Figure 11-3 Predicted ground-borne noise levels – residential receivers

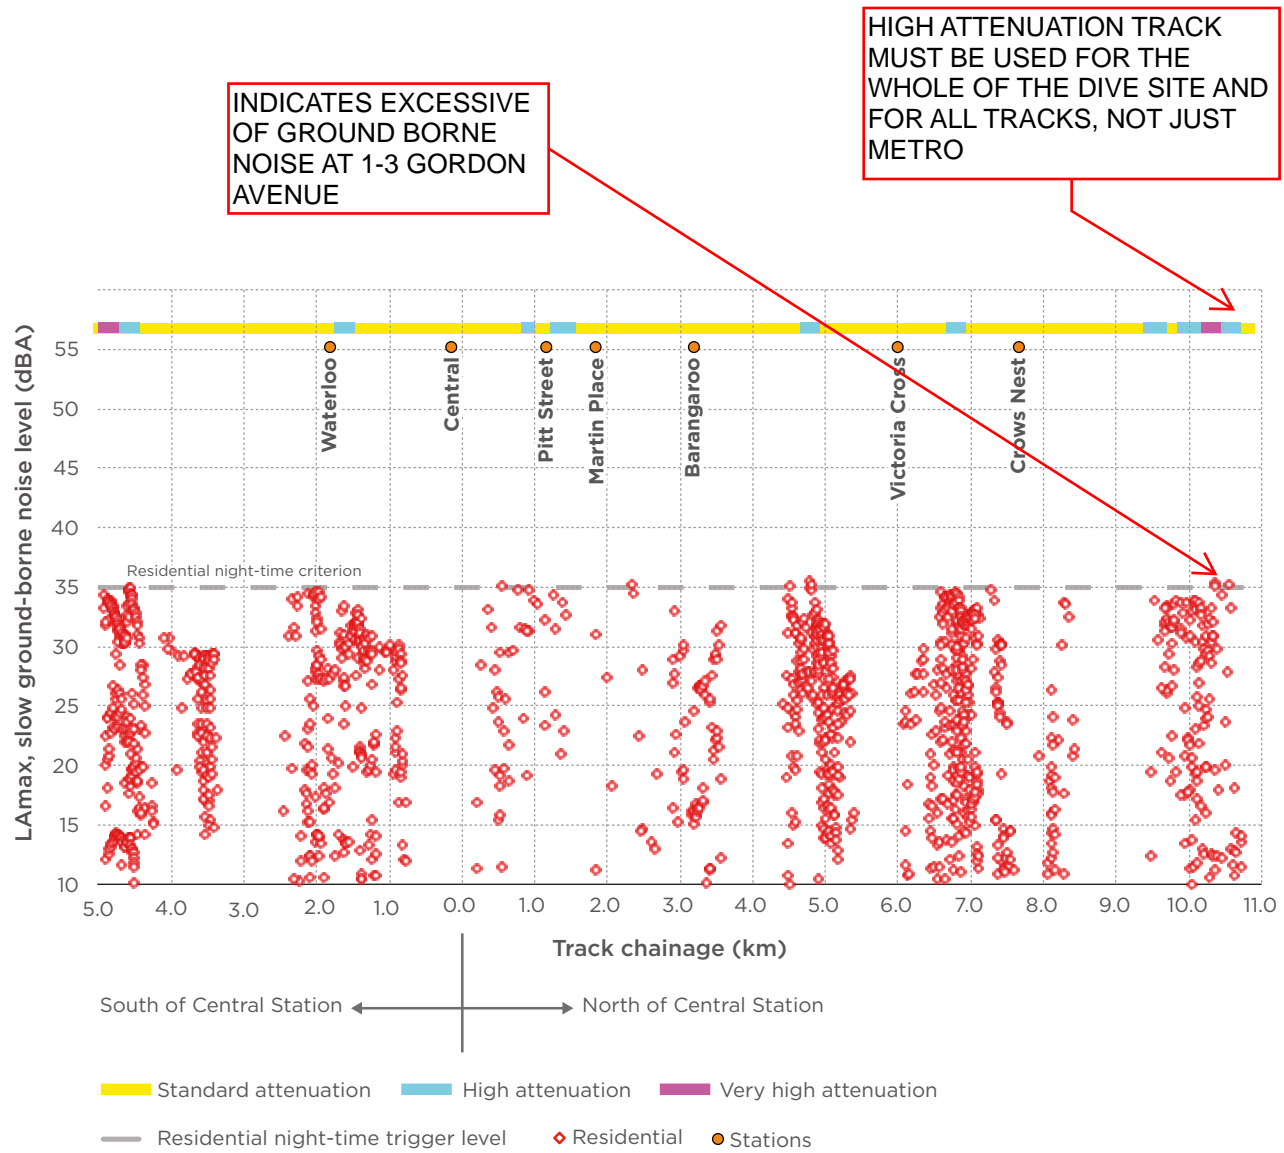
THIS SEVERELY AFFECTS 1-3 GORDON AVENUE. A "BARELY NOTICEABLE" INCREASE ON AN ALREADY UNACCEPTABLE LEVEL IS NOT ACCEPTABLE

THIS INCREASE OPPOSITE 1 GORDON ACTUALLY WILL CREATE GREATER REFLECTED NOISE TO THE UPPER FLOOR OF OUR BUILDING.
